ADDENDUM NO. 2

4th Street/US 73 (Choctaw to Seneca) Street Improvements
Leavenworth Project No: 2022-939
Project Bid Date: June 4, 2024 @ 3:00 p.m.

Addendum Issued: May 29, 2024

4TH STREET RECONSTRUCTION LEAVENWORTH, KANSAS TRAFFIC SIGNAL MAST ARM STANDARD FOOTING DETAIL

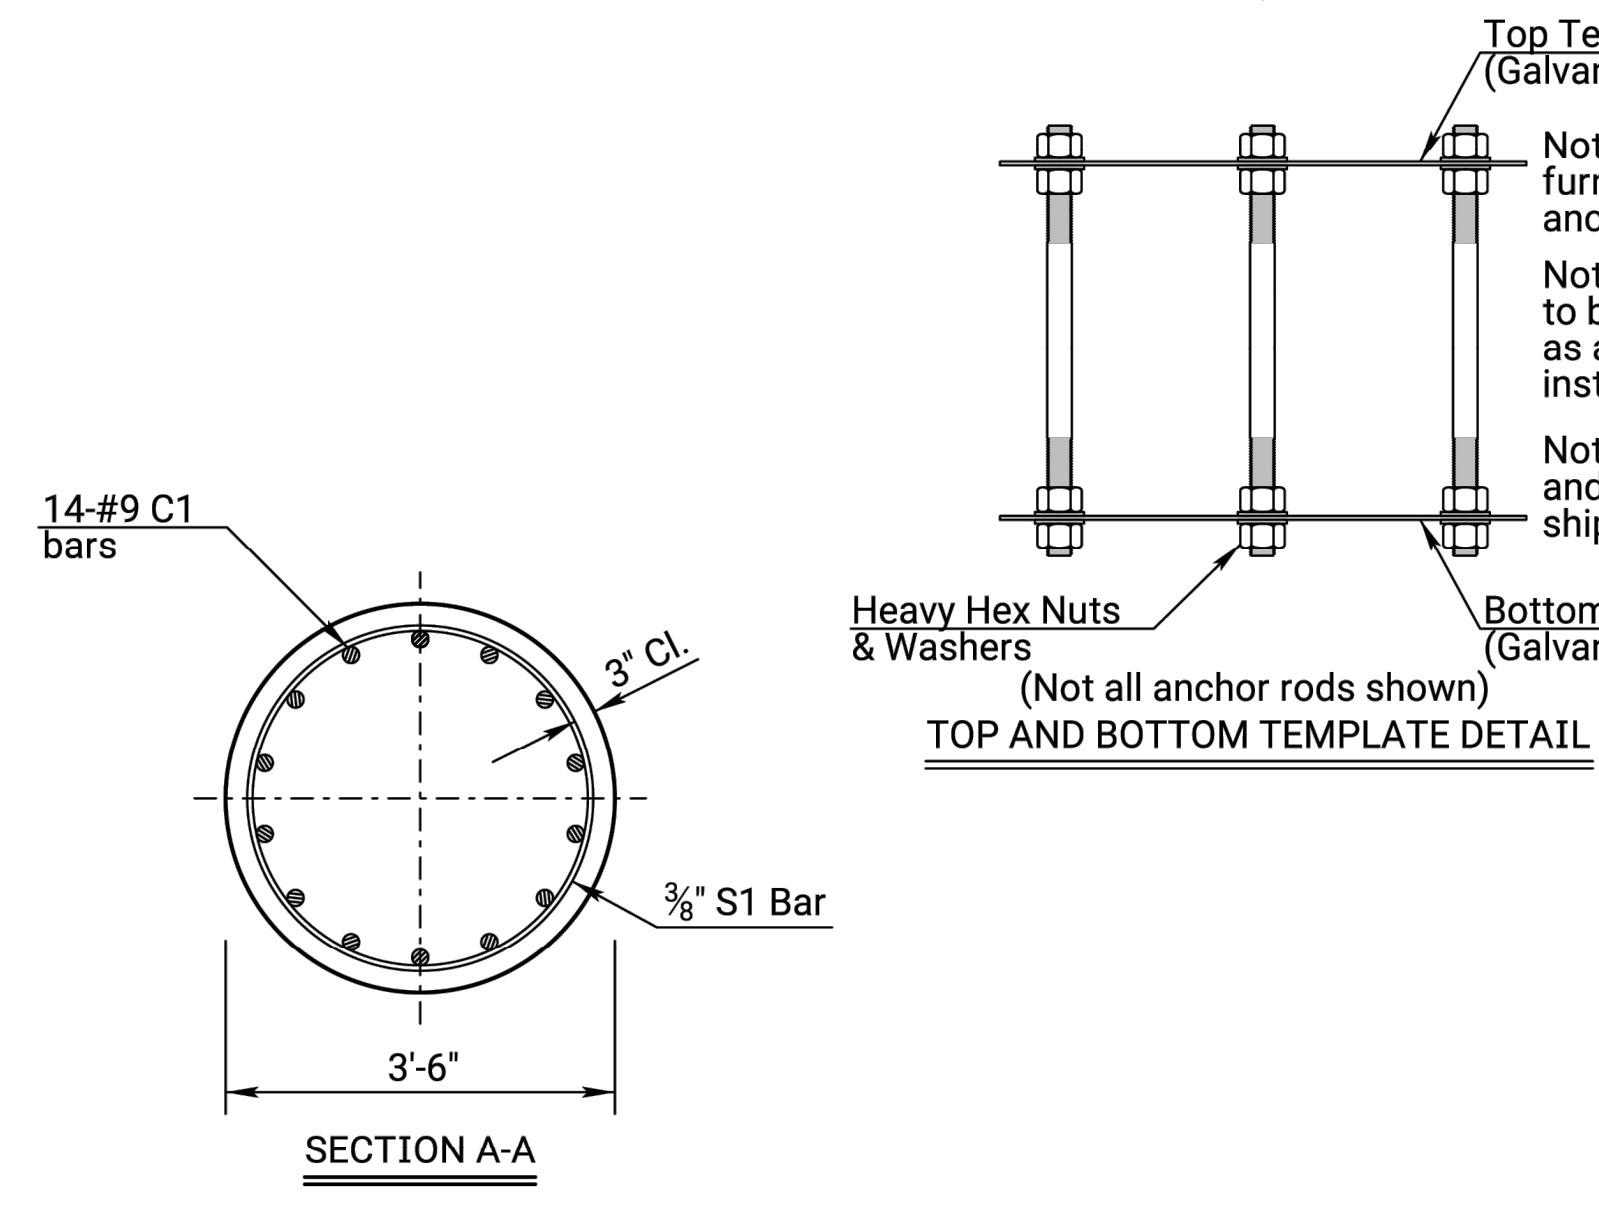
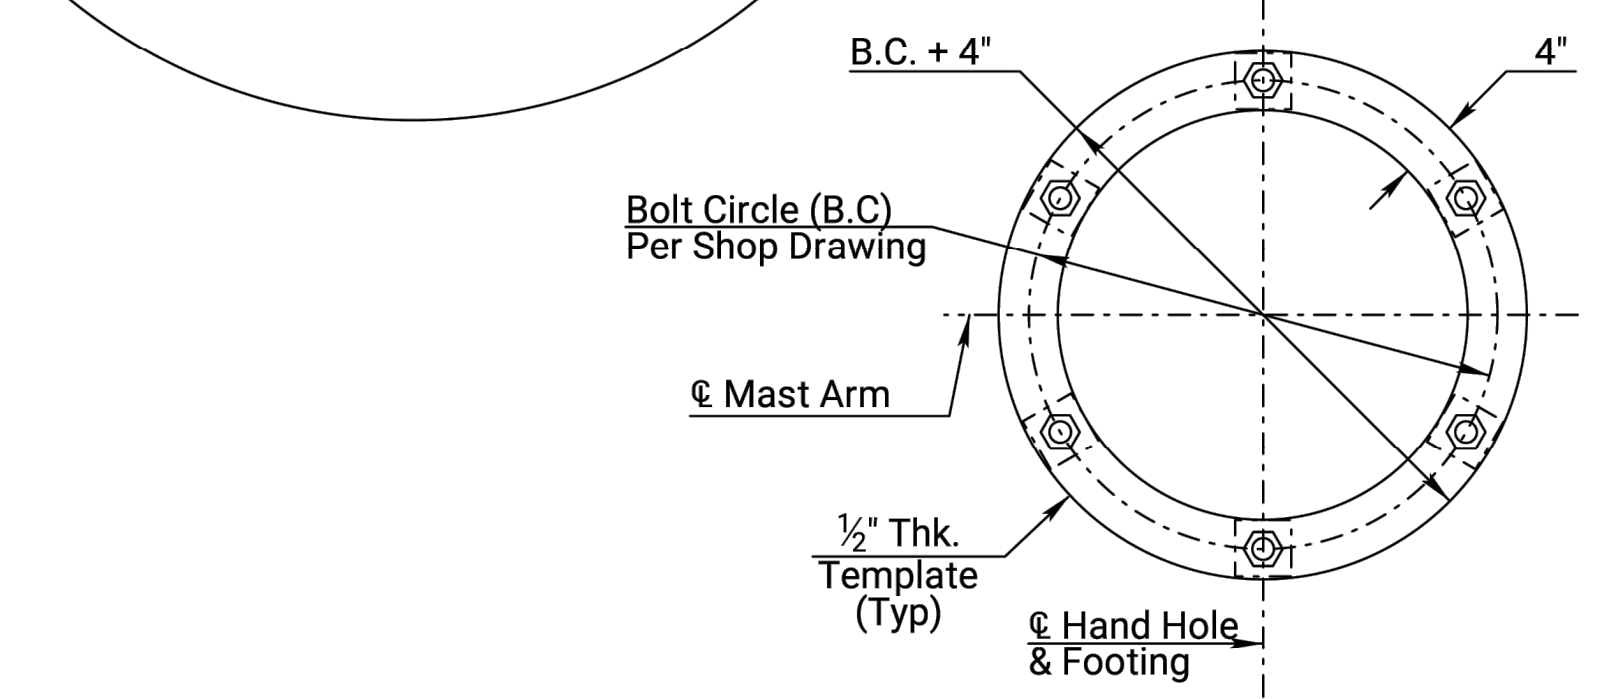
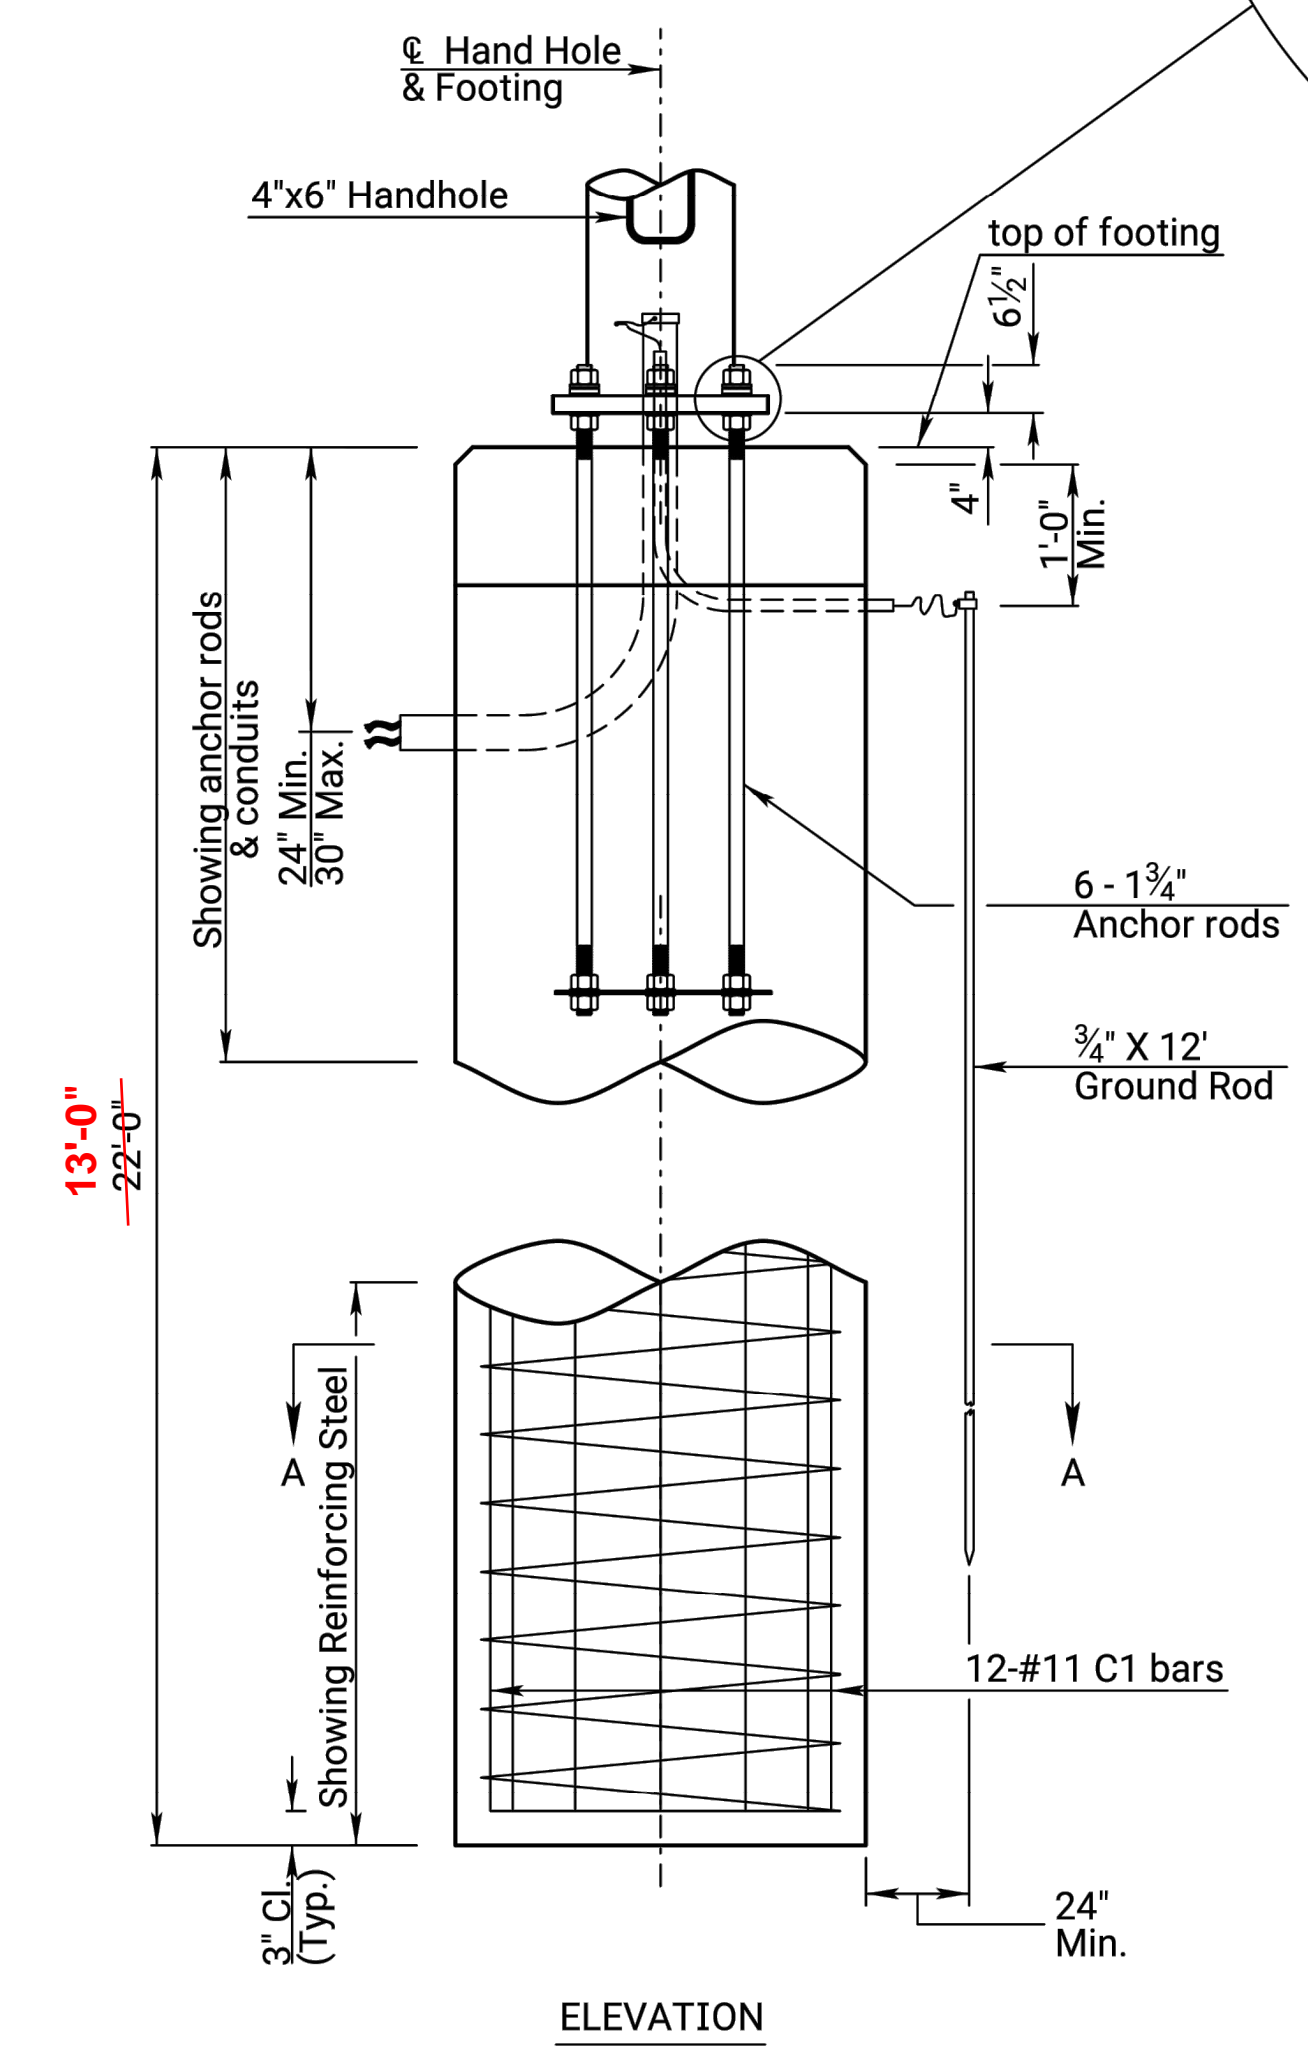
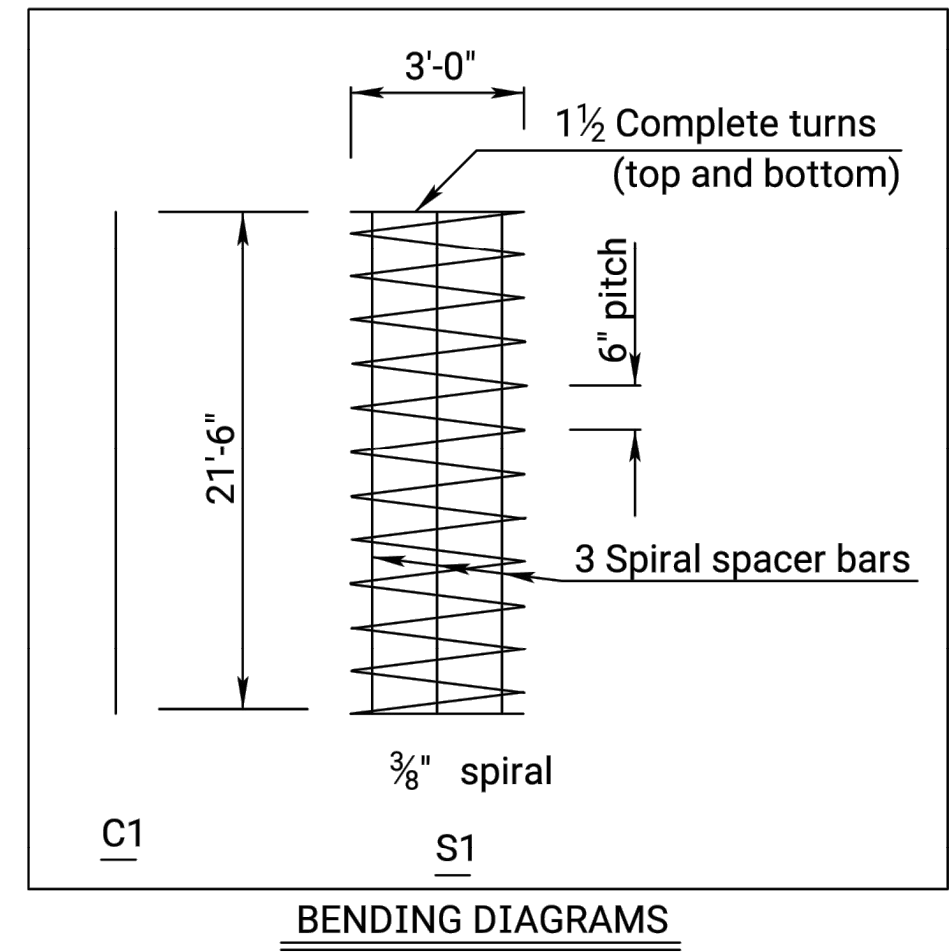
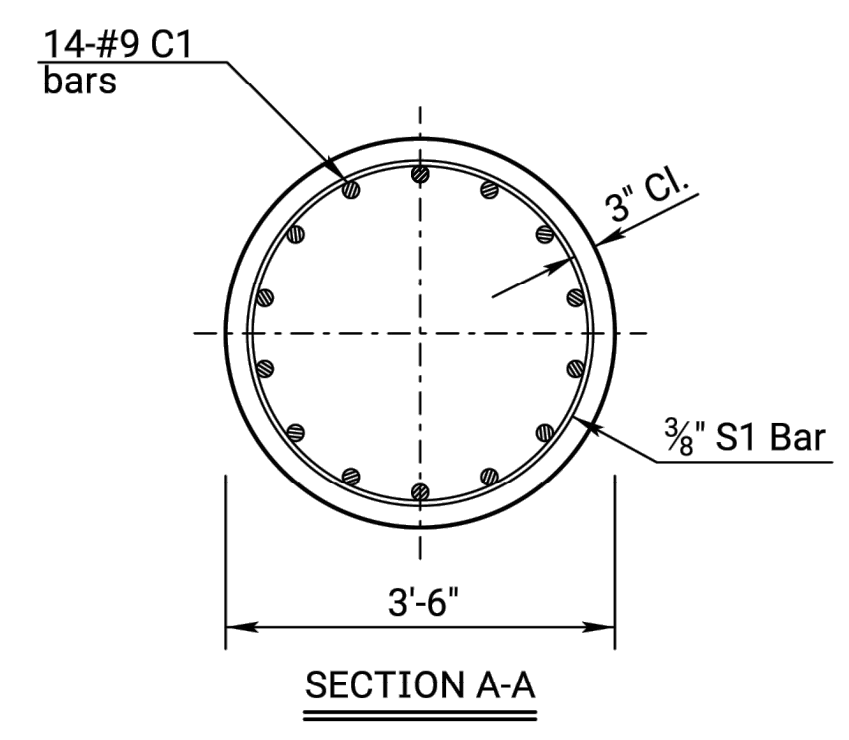
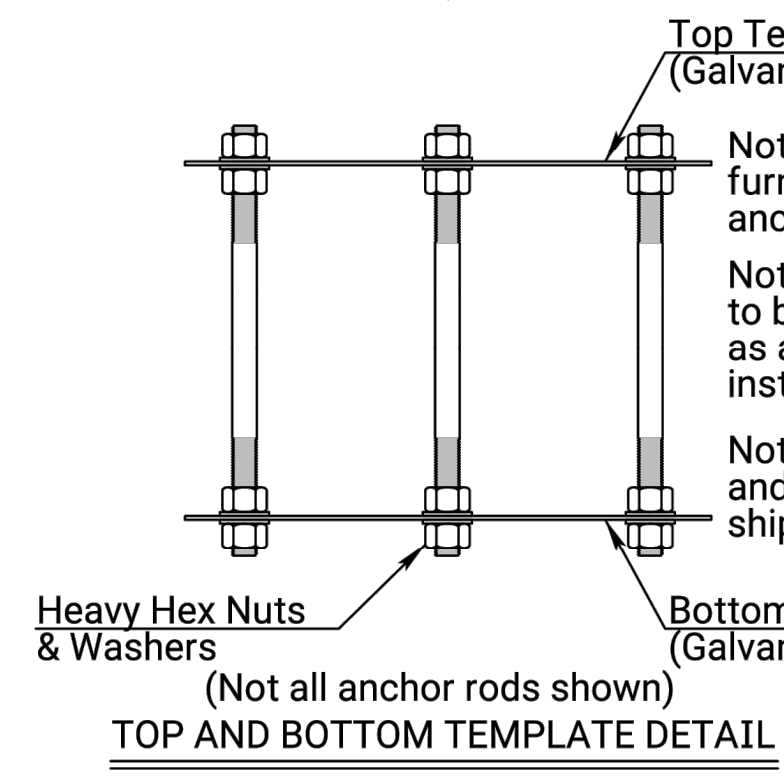
3. **CONSTRUCTION PLANS** are revised to replace Sheet 80 with the attached updated versions of this sheet. The revision reduces the required depth of the pole foundation to be 13 feet (revised from originally required 22 feet).

13. Depth of Signal Pole Foundations
- Addendum #2 revises the plans to only require traffic signal pole foundations to be 13' deep (not 22' deep).
14. Temporary Surfacing Aggregate – Is this just to be used as needed?
